2022 D-9/ ASHE WORKSHOP

JOINT MGMT/ IIC COUNCIL QUALITY EFFORT

To identify focus areas where the potential for quality improvements may exist that would provide mutual benefit to both Design and Construction

EXAMPLE #4

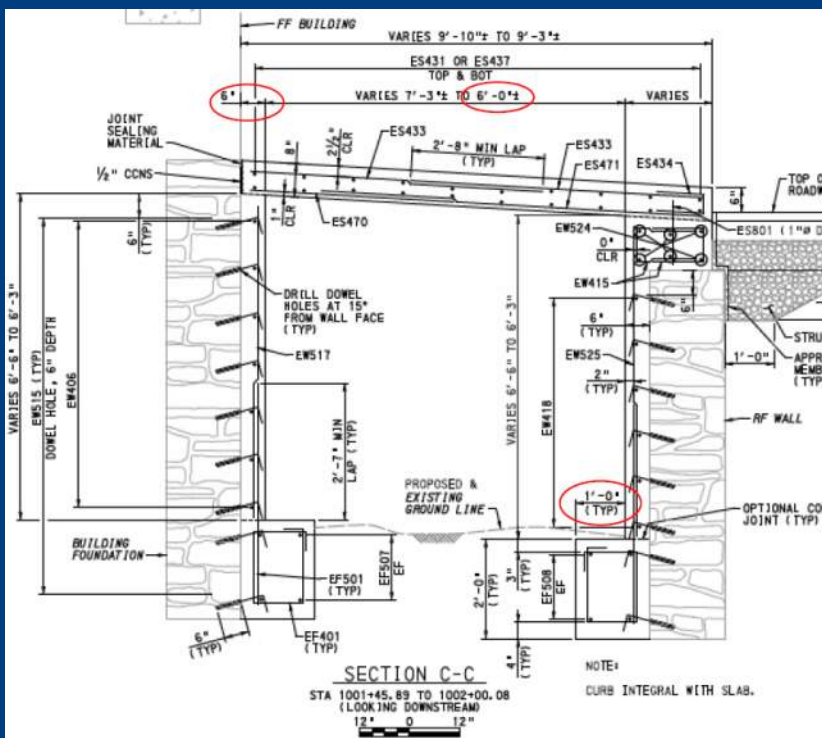
- Temporary Channel Diversion detail on E&S Plan appears to show adequate work area, showing a minimum diversion width of 2' (but no minimum height)
- 6'-0" minimum clearance after encasements shown on Section C-C of the structure plan
- Sandbags are shown set once down the middle of the stream and just switching the bags at upstream and downstream ends between each phase/ side of work
- Underpinning 1'-6" (1' beyond 6" encasement) on each side, so clearance between underpinning is 4' minimum
- Bags would need stacked vertically in order for contractor to have 1' work area on each side of diversion ($4' - 2' / 2 = 1'$)

EXAMPLE #5

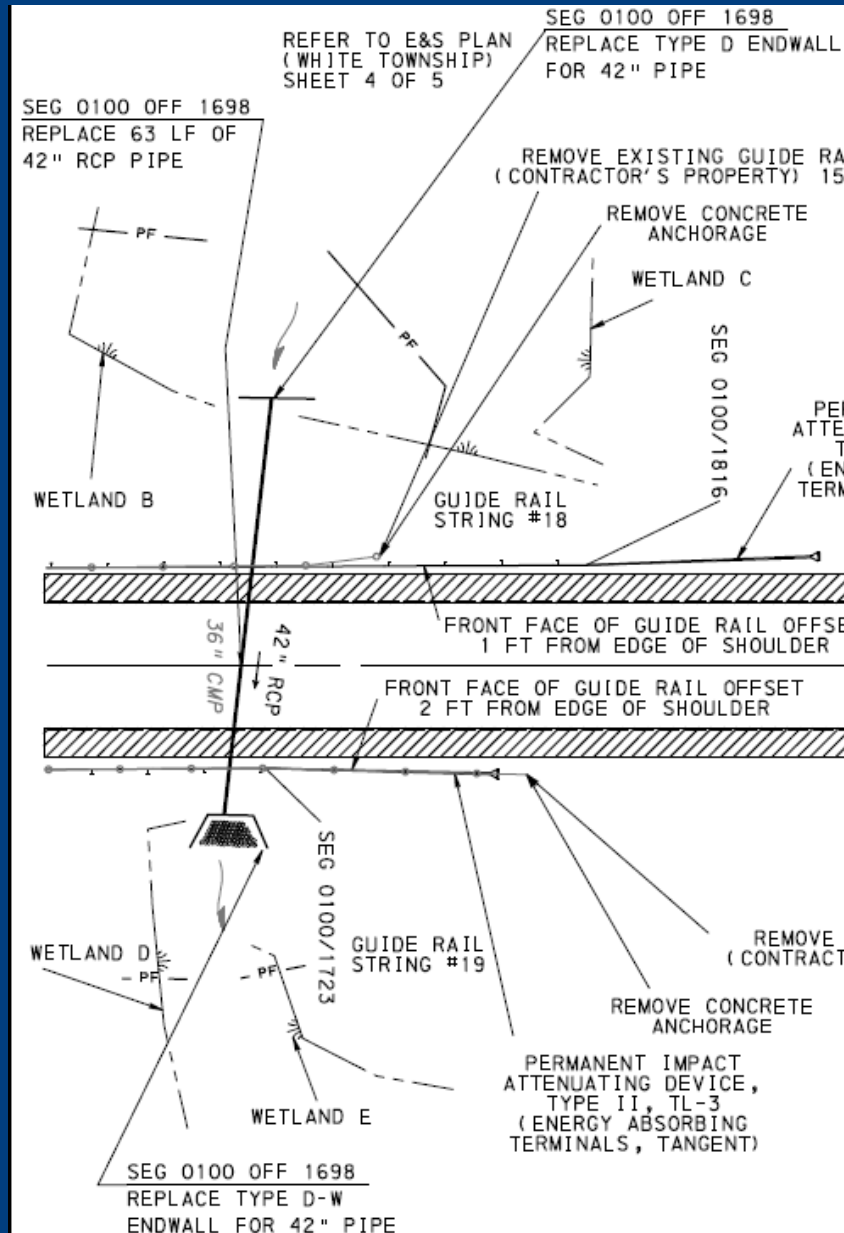
- Replacing existing 36" cross pipe with a new 63' long, 42" cross pipe
- Notice the distance from the guiderail to the ends of pipe on this drawing (which is to scale)

EXAMPLE #5 (cont.)

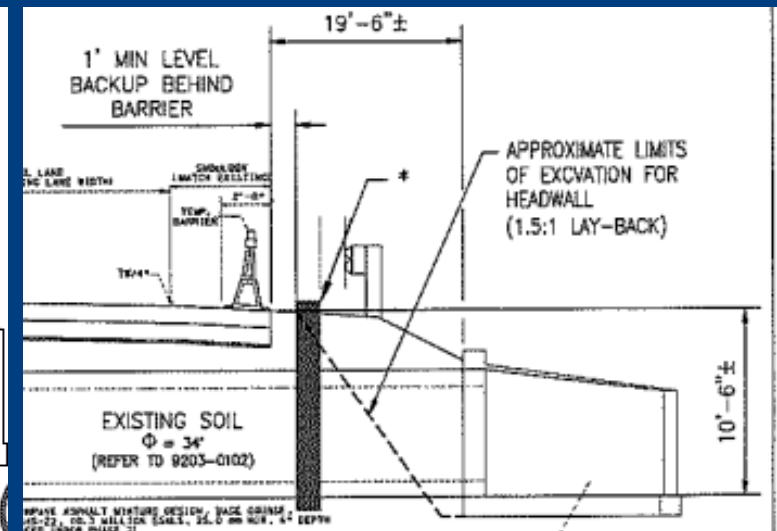
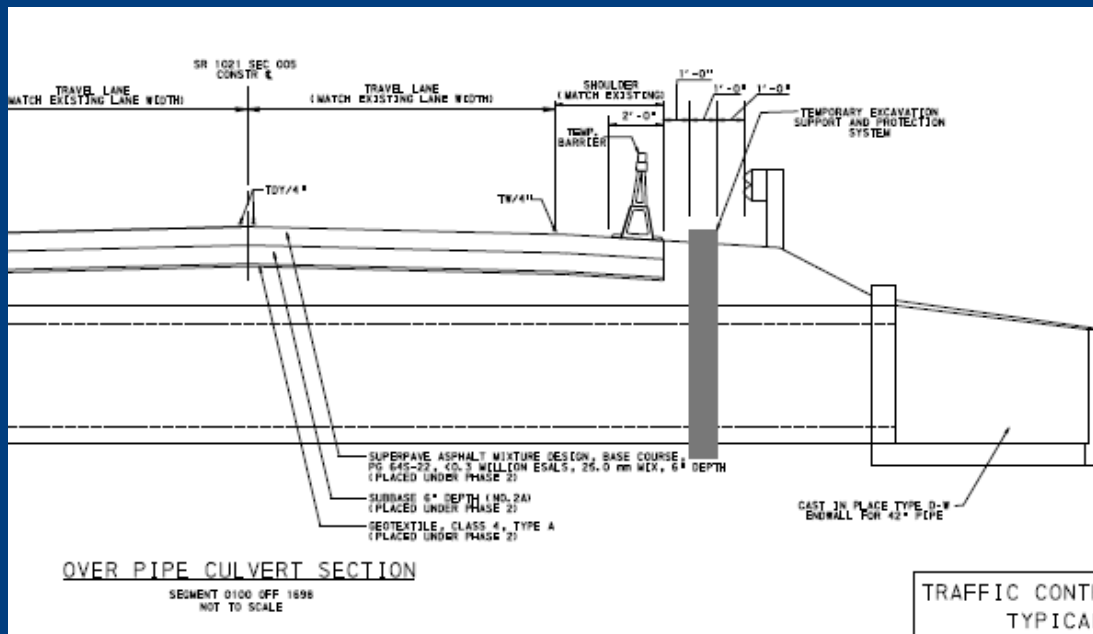
- Detail shown on TCP, NTS detail calls for shoring on downstream end of pipe
- Contractor field measures over 19'-6" from back of proposed temporary barrier to back side of headwall and cut depth of roughly 10'-6"
- Therefore, slope can be laid back at 1.5 to 1 and no shoring is required
- Item Description - "This work is the design and construction of a temporary excavation support and protection system or appropriately designed open cut excavation" (so we pay full price on item anyway)

EXAMPLE #5 (cont.)

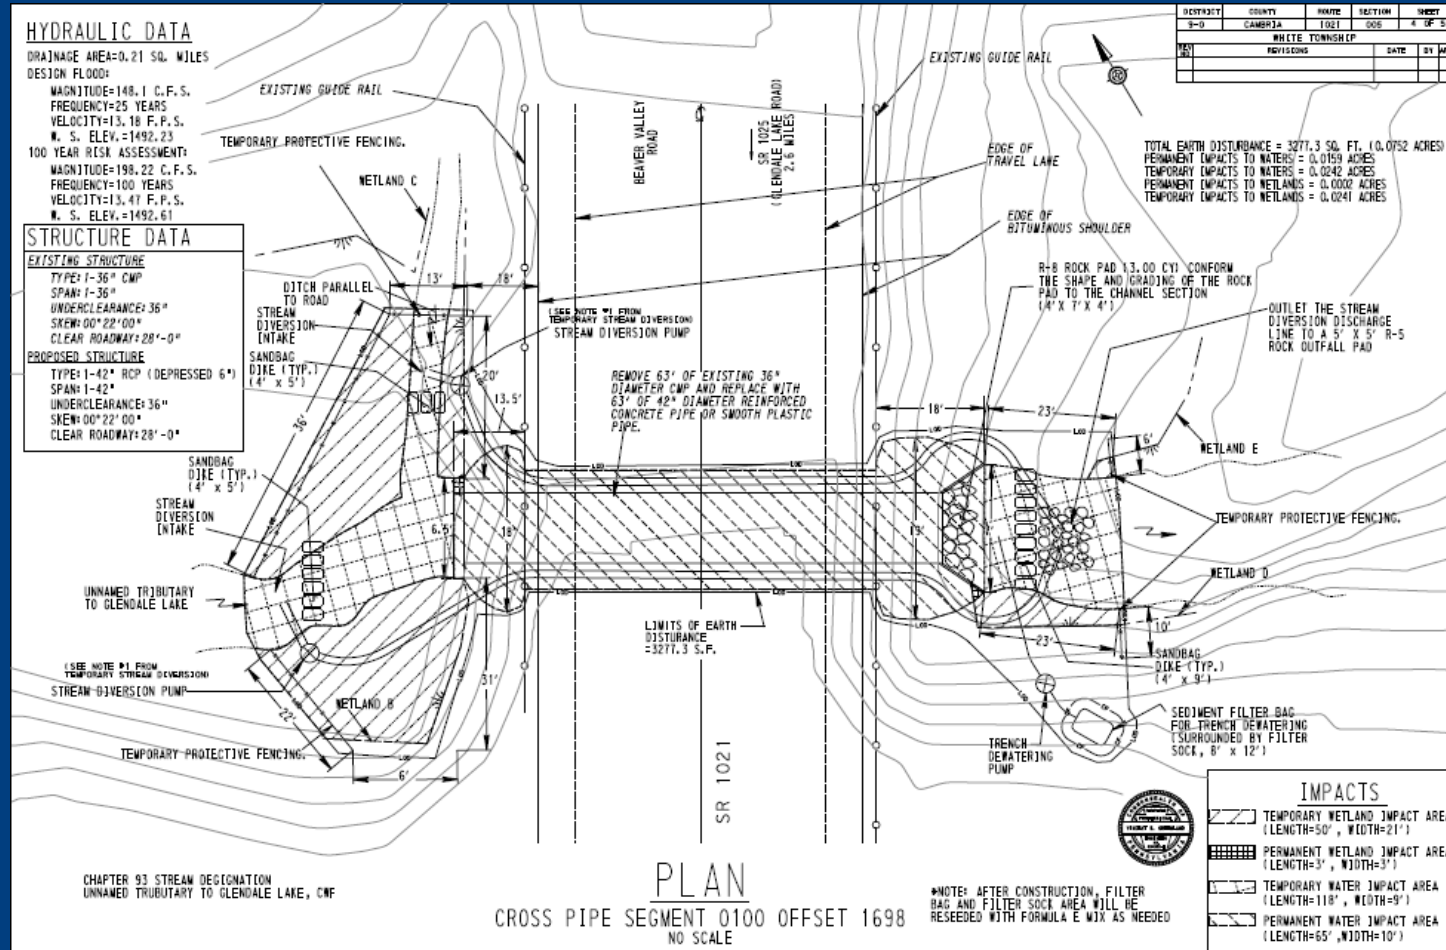
- Detail shown on E&S Plan ~ understand NTS, but looks completely different than 'to scale' plan

EXAMPLE #1

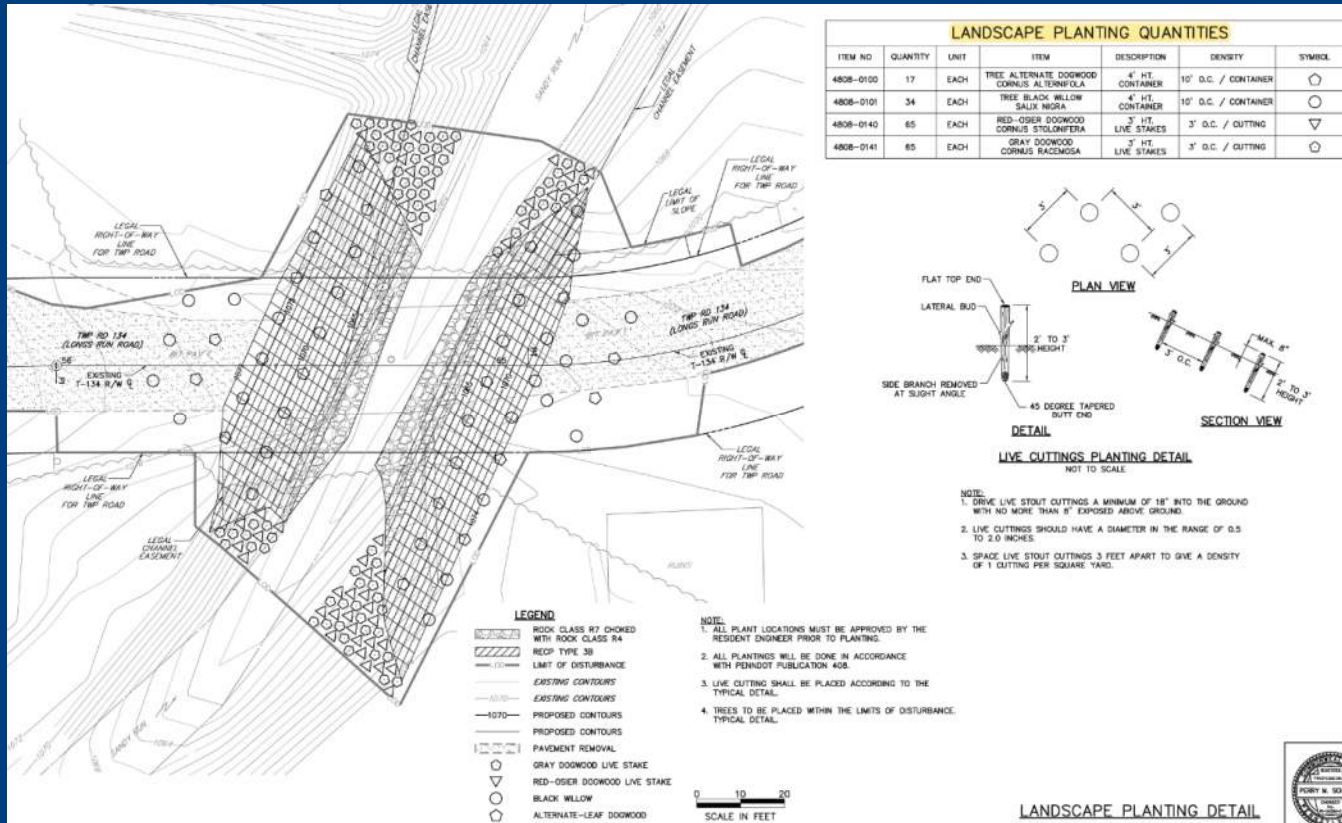
- ECMTS defines environmental commitment for environmental monitoring and sampling and disposal of contaminated media
- There were no bid items included in the contract for this work
- These items become very costly when added after the project is bid
